Work Order ID 151372

Item Name: Doubler

APICAL INDUSTRIES, INC.	ENGINEERING CHANGE NOTICE NO. 03985			SHEET 1 OF 2	
	DWG NO. 647.0100	REV: A	PREPARED BY J. BECKER	DATE: 7/15/13	EFFECT ON DWG ☐ INC. ☒ UNINC.
	DWG TITLE: SHEET METAL				
APPROVED BY: ENGR. 		MFG 	QC 	EFF. NEXT ORDER	
TRANSACTION CODES (TC): A-ADD C-CREATE R-REVISE D-DELETE		REASON: REVISED NOTE 2. ADDED 647.0117

SHEET 1, ZONE D1 IS:

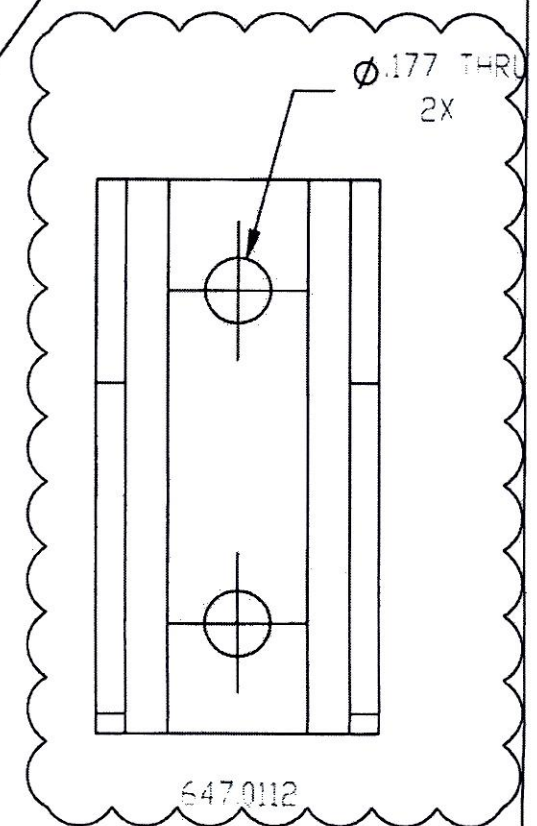
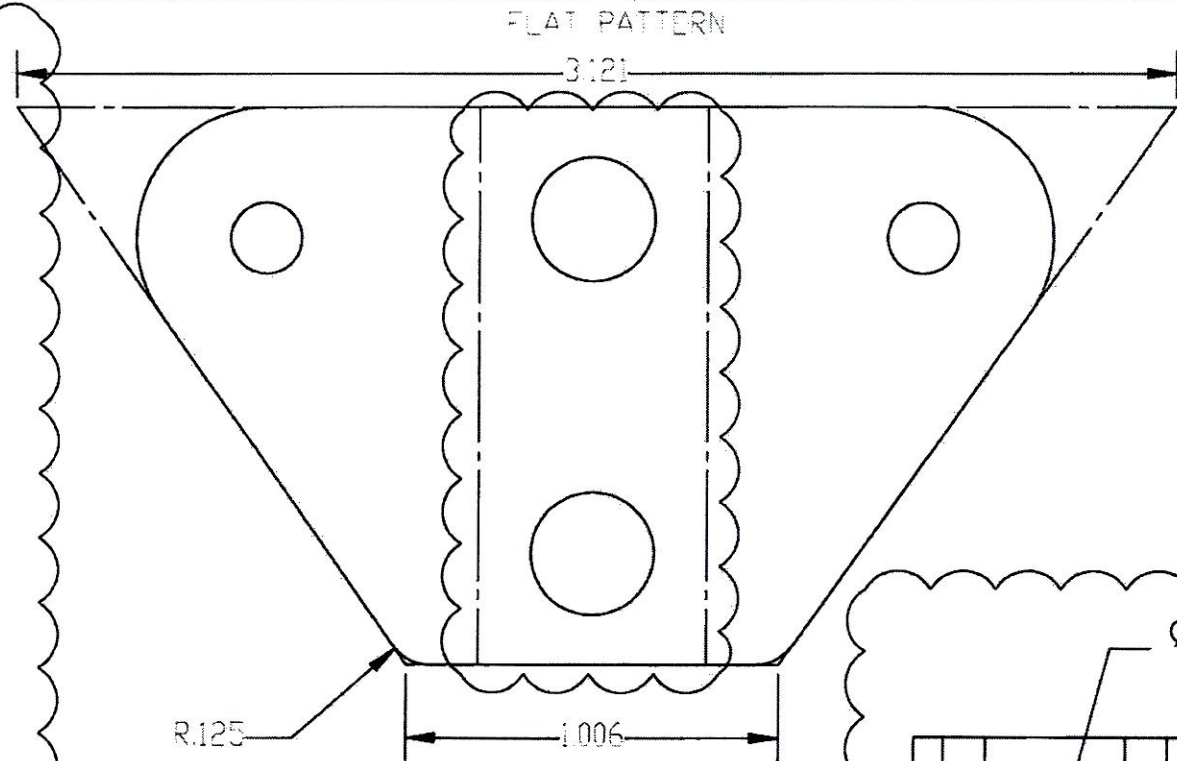
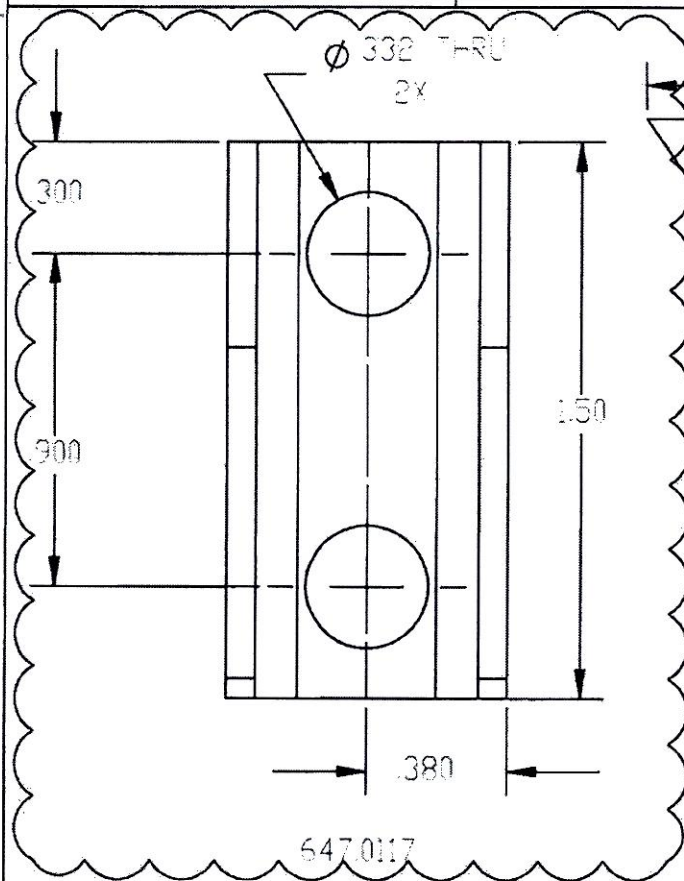
- 1 MATERIAL: ALUMINUM 2024-T3 PER AMS-QQ-A-250/4.
- 2 FINISH: IAW MPP-172 ANODIZE IAW SECTION 2.1, PRETREATMENT IAW SECTION 3.1 AND PRIMER IAW SECTION 4.1.
3. DEBURR AND BREAK ALL SHARP EDGES.
4. IDENTIFY IAW MPP-120.
- 5 MATERIAL: 304 SS IAW AMS 5643.
- 6 FINISH: PRIME IAW MIL-P-23377J TYPE I CLASS N.
- 7 OTHER DIMENSIONS SAME AS 647.0112.

SHEET 3, ZONE B2-4 IS:

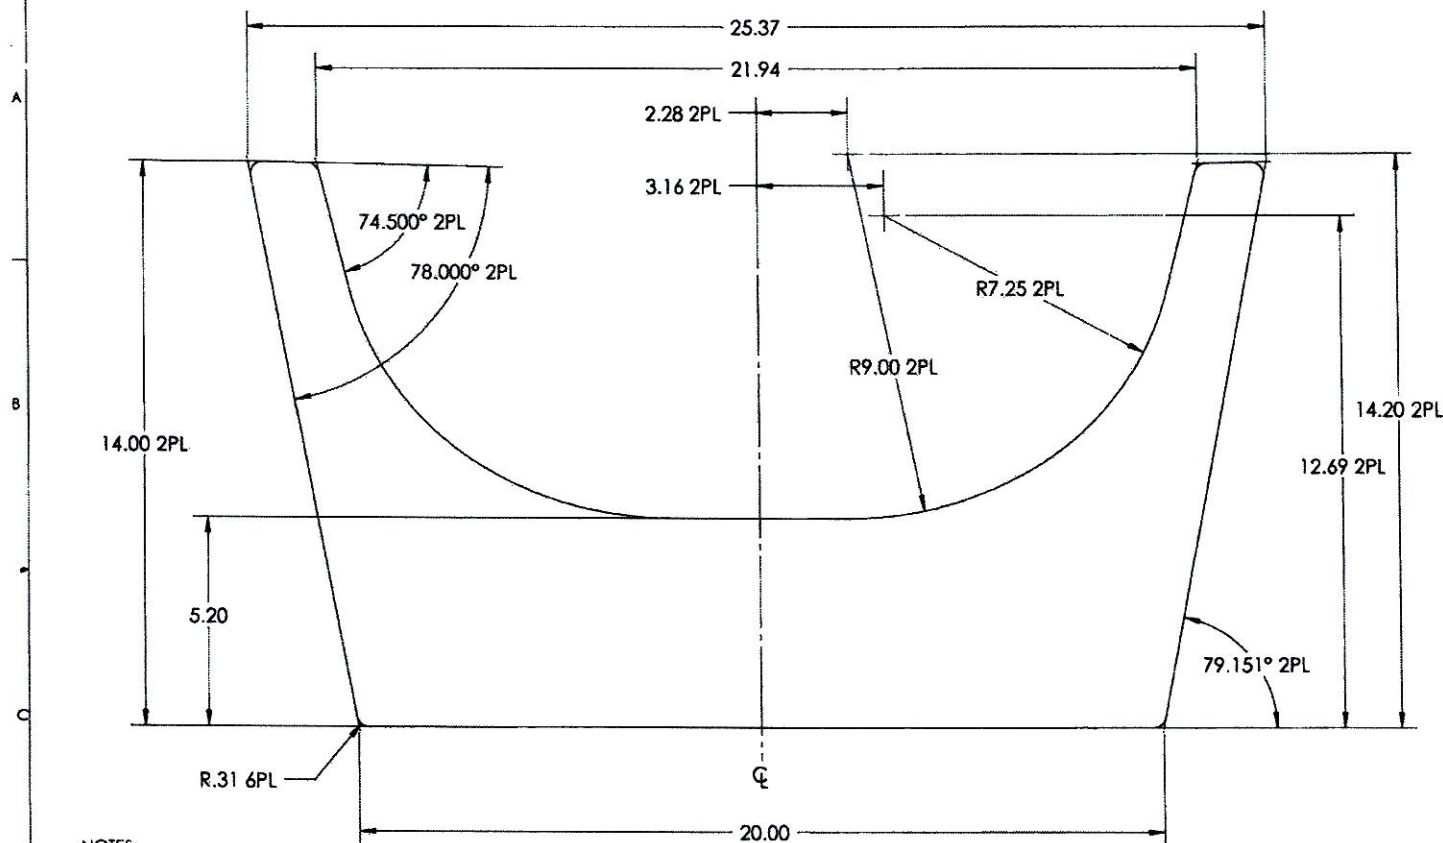
- 1 MATERIAL: ALUMINUM 2024-T3 PER AMS-QQ-A-250/4.
- 2 FINISH: HARD ANODIZE IAW MIL-A-8625 TYPE III, CLASS 2, COLOR BLACK; PRETREAT PR-148 ADHESION PROMOTER; PRIME IAW MIL-P-23377J TYPE I CLASS N.
3. DEBURR AND BREAK ALL SHARP EDGES.
4. IDENTIFY IAW MPP-120.
- 5 MATERIAL: 304 SS IAW AMS 5643.
- 6 FINISH: PRIME IAW MIL-P-23377J TYPE I CLASS N.
